Longfield Solar Farm

Applicant Comments on Submissions Received at Deadline 4

Document Reference: EN010118/EX/8.21

November 2022

Figure 1 – Approximate alignment of additional permissive path at the northern extent of the Order Limits, suggested by ELAF

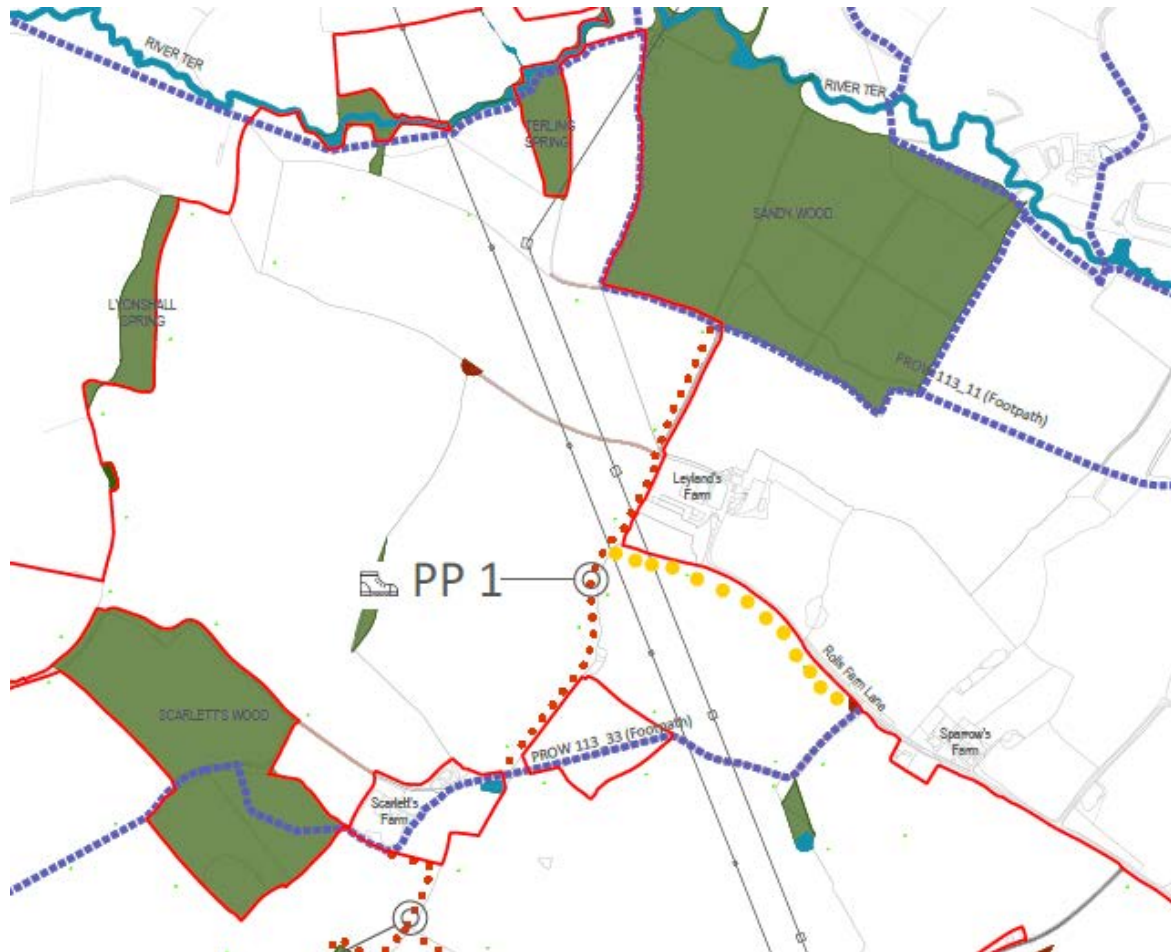
- (i) At the northern end, a connection to the permissive paths for cyclists and horse-riders, that is inside the pink wash land, could be to Rolls Farm Lane / Sparrows Farm Lane, which is a public road at the northern termination of Terling footpath 33 [113_33]. See Land Plan sheets 7 & 9.
- (ii) (ii) At the southern end the final western sections of the footpath connections to Waltham Road – Boreham footpath 18 or 19 [213_18 or _19] are outside the order limits so would require the permission of the landowner. The other connection along the cable route would also require landowner permission. See Land Plan sheets 3 & 2.

The response provided by ELAF requests that an additional permissive path is provided towards the northern end of the Order limits, connecting Rolls Farm Lane to Permissive Path 1, thereby providing access to cyclists and equestrian users (as shown in Figure 1 overleaf). However, were this to be provided, it would afford a limited increase in access to cyclists and equestrian users given the constraint in accessing ongoing routes posed by connecting footpaths (PROW 113_11 to the north and PROW 113_33 to the south).

The yellow route highlighted in Figure 1 shows approximate alignment of additional path suggested by ELAF. Were this to be provided, it would afford a limited increase in access to cyclists and equestrian users given the constraint in accessing ongoing routes posed by connecting footpaths, as detailed in the Applicant's response above.

Figure 2 – Approximate alignment of additional permissive path at the southern extent of the Order Limits, suggested by ELAF

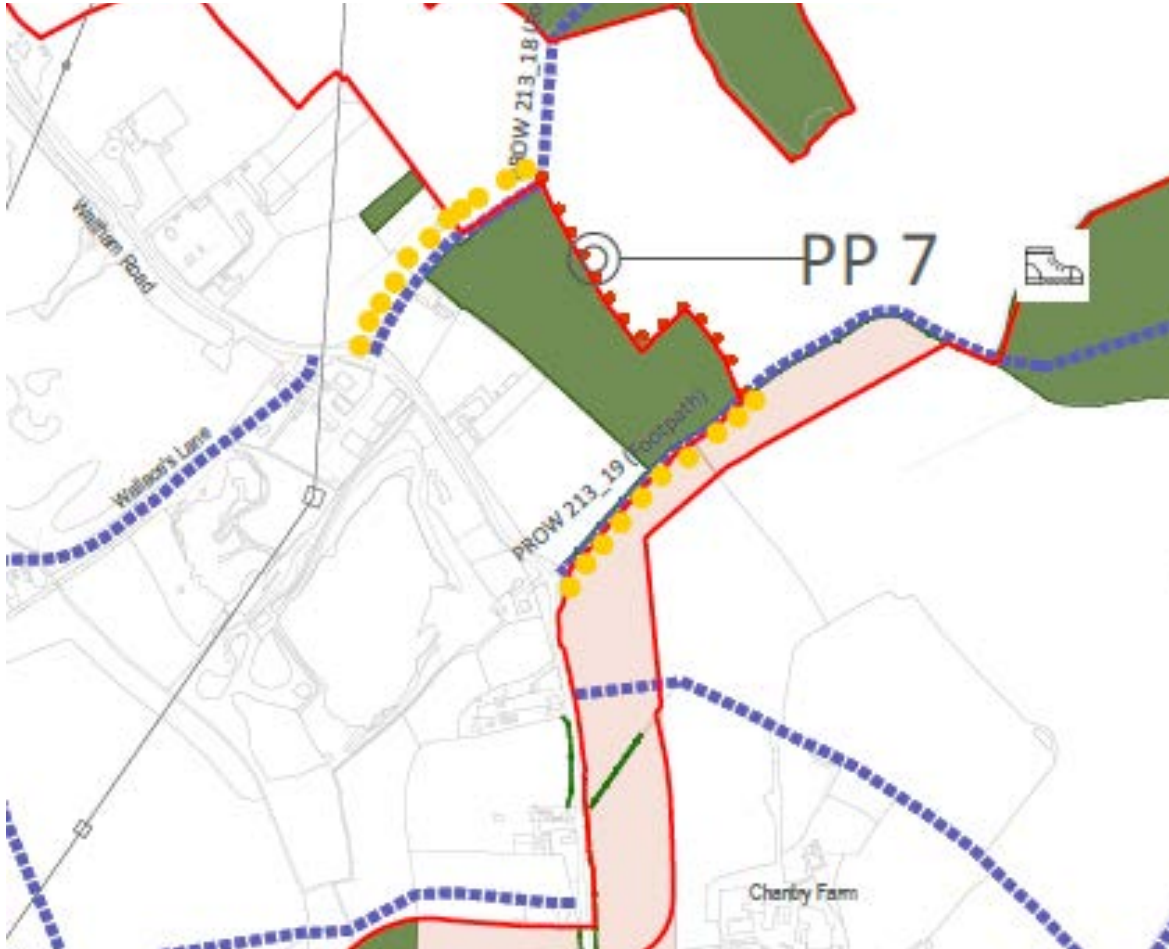
Additional connections were also requested by ELAF at the southern end of the Order limits (as shown in Figure 2 overleaf). However for the northern option shown (PROW 213_18), this would require land outside of the Order limits and would therefore be beyond the scope of the Scheme. For the southern option (PROW 213_19), this is constrained by existing hedgerows.

The yellow route aligned with PROW 213_18 shows the approximate alignment of additional path as suggested by ELAF. This is not considered a viable option since it crosses land outside of the Order limits.

The yellow route aligned with PROW 213_19 shows the approximate alignment of the additional path suggested by ELAF. However this is constrained by existing hedgerows and its location within Work Number 4, identified only for works associated with the Grid Connection.
